Land at Crowell Road, Chinnor, Oxfordshire

Highways Statement of Common Ground

Highways Statement of Common Ground

Application Reference P21/S0804/O
PINS Reference APP/Q3115/W/21/3289271

Drawing No.: 3636.P.110 Revision: G

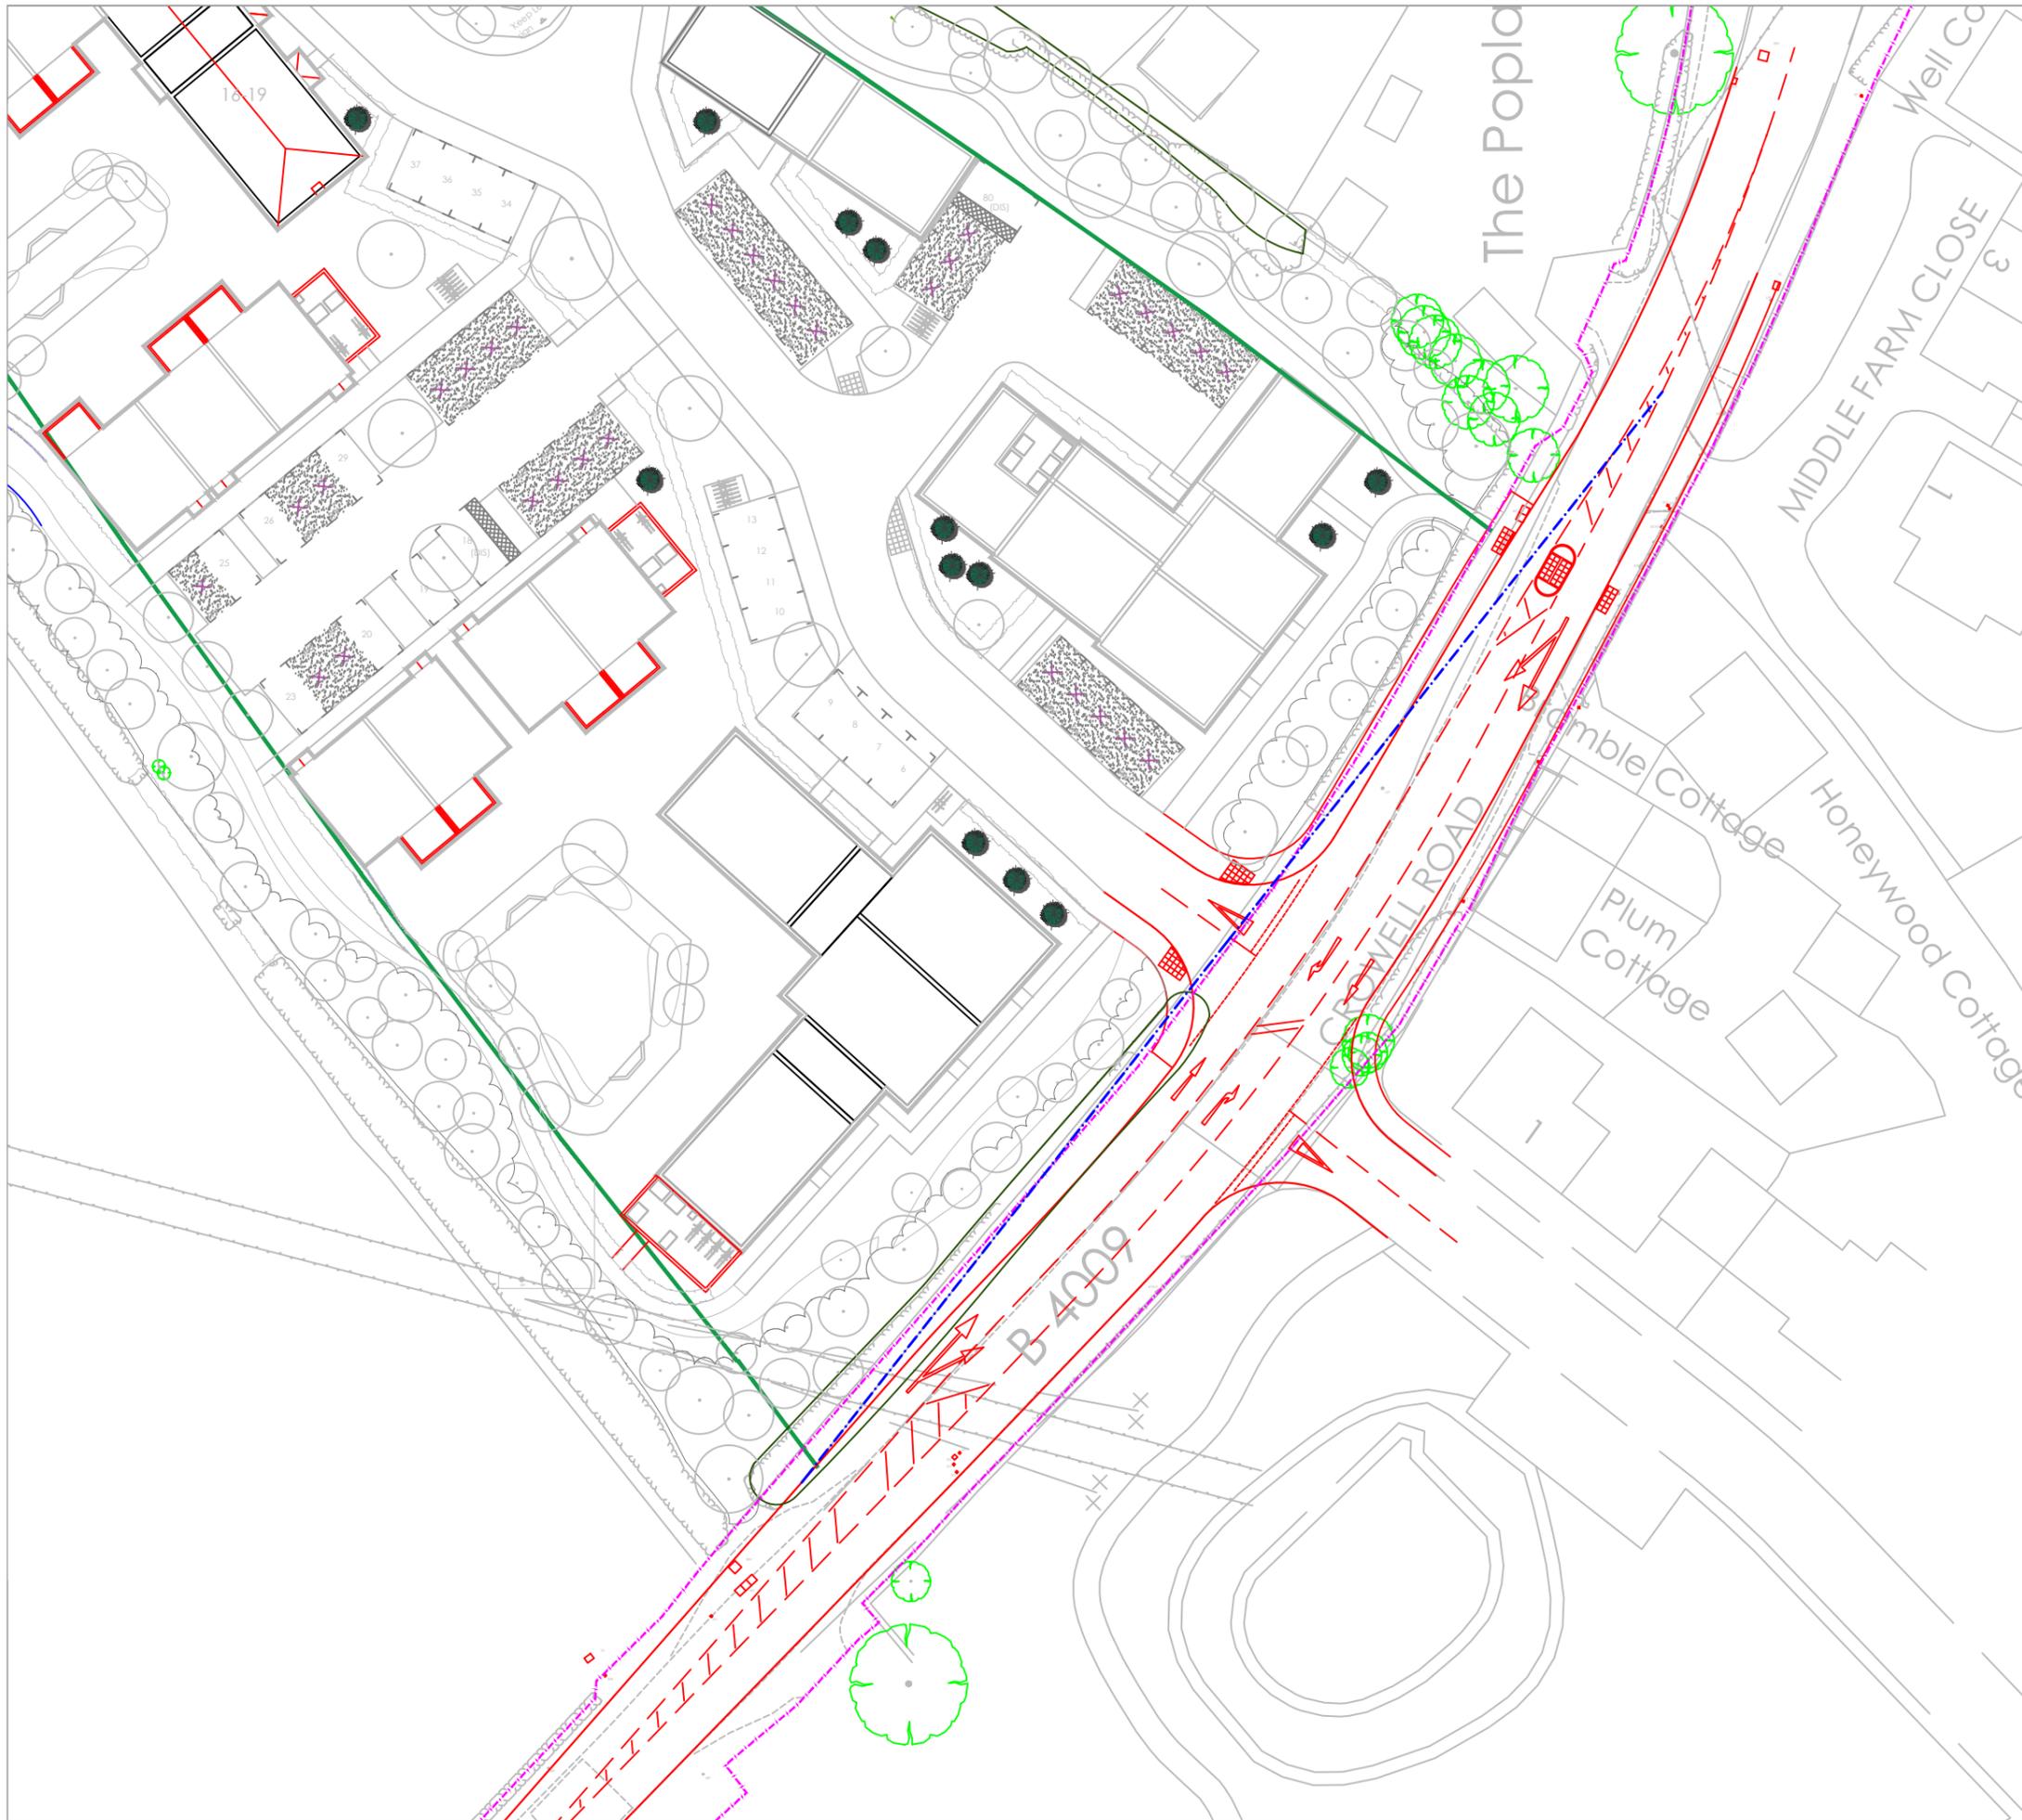
- Agreed revised Drawing is J32-5511-PS-001 Rev B
- 3) Prior to the first occupation of the development hereby approved, the parking and turning areas shall be provided in accordance with the approved plan 3636.P.110, Rev D and shall be constructed, laid out, surfaced, drained and completed to be compliant with sustainable drainage (SuDS) principles, and shall be retained unobstructed except for the parking of vehicles associated with the development at all times. Reason: In the interests of highway safety and in accordance with Policy TRANS5 of the South Oxfordshire Local Plan 2035.

- 3) Prior to the first occupation of the development hereby approved, the parking and turning areas shall be provided in accordance with the approved plan 3636.P.110, Rev D and shall be constructed, laid out, surfaced, drained and completed to be compliant with sustainable drainage (SuDS) principles, and shall be retained unobstructed except for the parking of vehicles associated with the development at all times.

- Agreed revised Plan is 3636.P.110 Rev G
- 4) Prior to the occupation of the development here by approved, cycle parking facilities will be provided in accordance with details to be submitted to and approved in writing by the Local Planning Authority, prior to the commencement of development. Reason: To encourage the use of cycles as a means of transport in accordance with Policy TRANS5 of the South Oxfordshire Local Plan 2035.

13. Identified Road Safety Audit Matters location plan

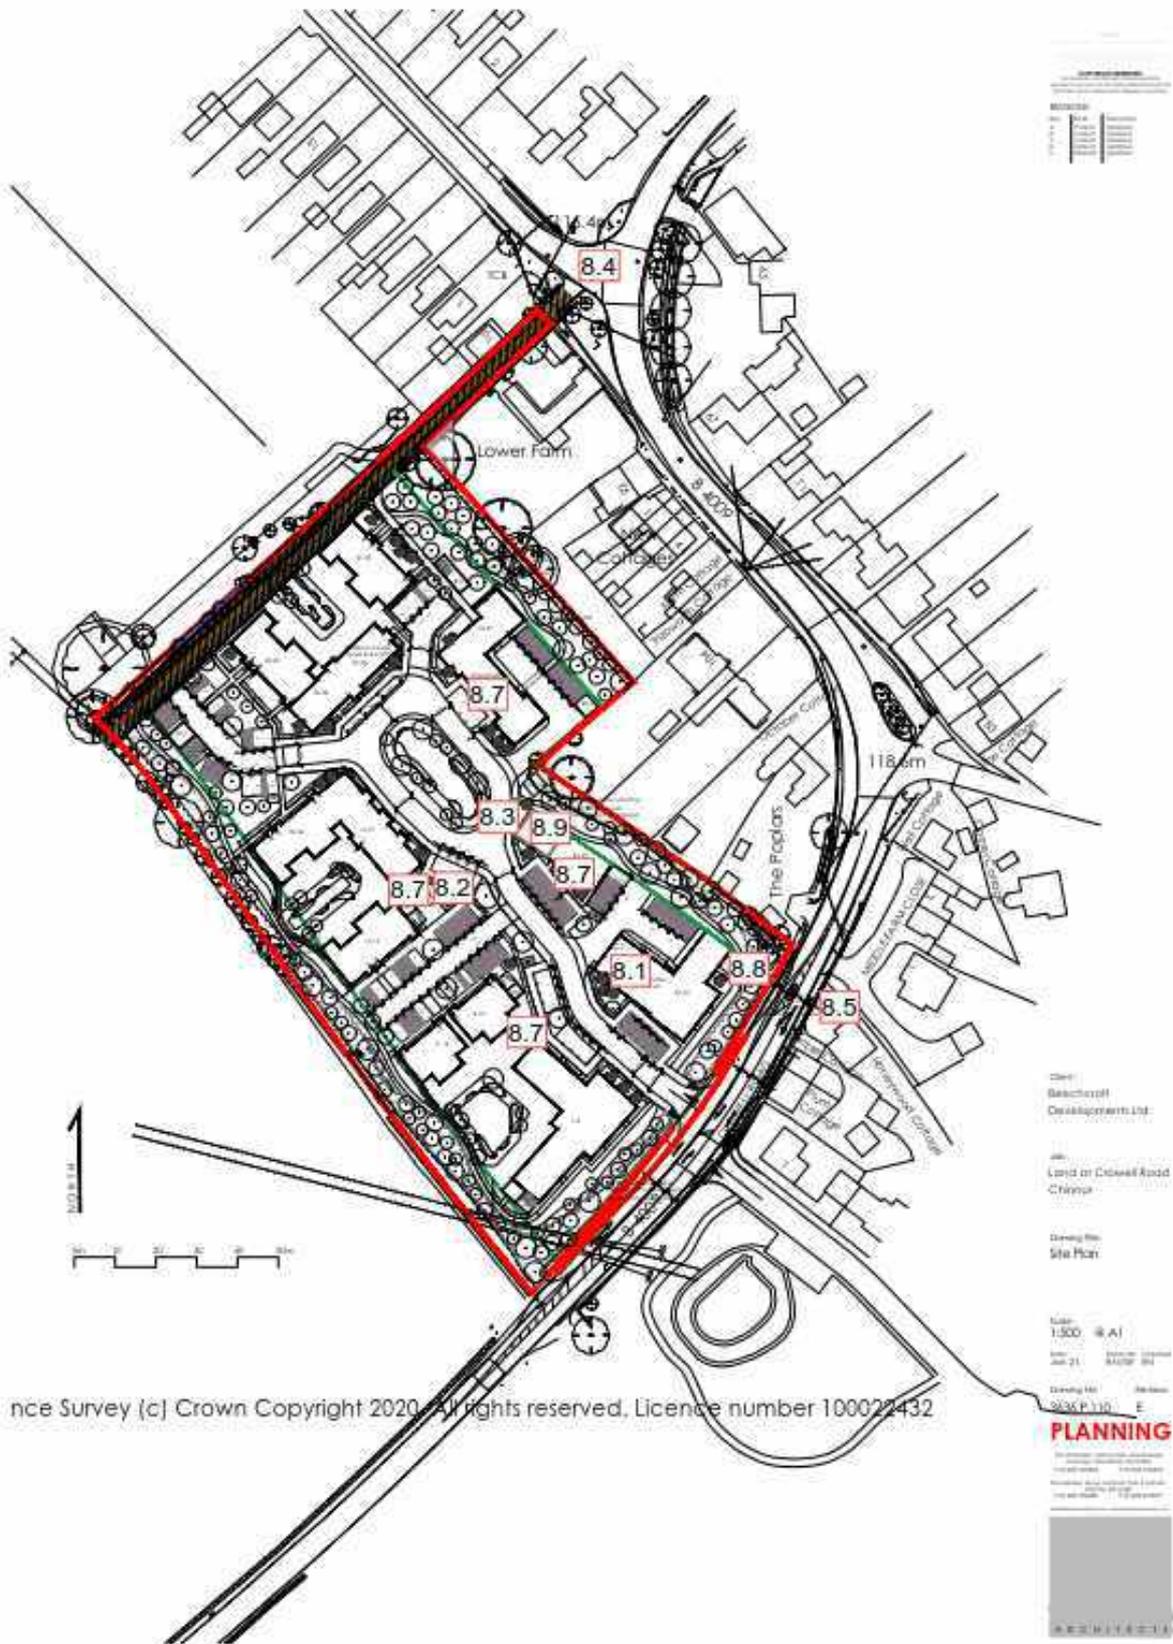
8.1 *Problem* (Item A1.12)	
Location:	Carriageway adjacent to plots 46-54
Summary:	No clearance from building to adjacent carriageway
A new building is detailed without any clearance from the adjacent carriageway. This may result in vehicle collisions with the building. Provide required clearance from building to adjacent carriageway.	
TYPE OF CONFLICT/COLLISION	
Vehicle collisions with building.	
RECOMMENDATION	
Amend design

8.2 *Problem* (Item A3.1)	
Location:	Parking bays 34-37
Summary:	There are parking bays detailed at the start of the one-way gyratory carriageway around the central island. Vehicles may ignore one-way when exiting parking spaces
There are parking bays detailed adjacent to the start of the one-way gyratory carriageway. Vehicles may ignore the one way when exiting from these parking spaces causing collisions with vehicles coming in the opposite direction. Amend carriageway layout at parking bays to remove conflict.	
TYPE OF CONFLICT/COLLISION	
Collisions due to vehicles ignoring one-way.	
RECOMMENDATION	
Amend carriageway layout.

8.6 *Problem* (Item A4.2)	
Location:	Various locations
Summary:	No pedestrian crossing points detailed where required at junctions between footways
There are no dropped kerb /tactile paved pedestrian crossing points detailed across roads where pedestrians will be expected to cross over the roads between footways near junctions. Provide pedestrian crossing points where required.	
TYPE OF CONFLICT/COLLISION	
Pedestrians having to cross over full height kerbs to cross over roads.	
RECOMMENDATION	
It is recommended that dropped kerb/tactile paved pedestrian crossing points be provided where required at junctions.
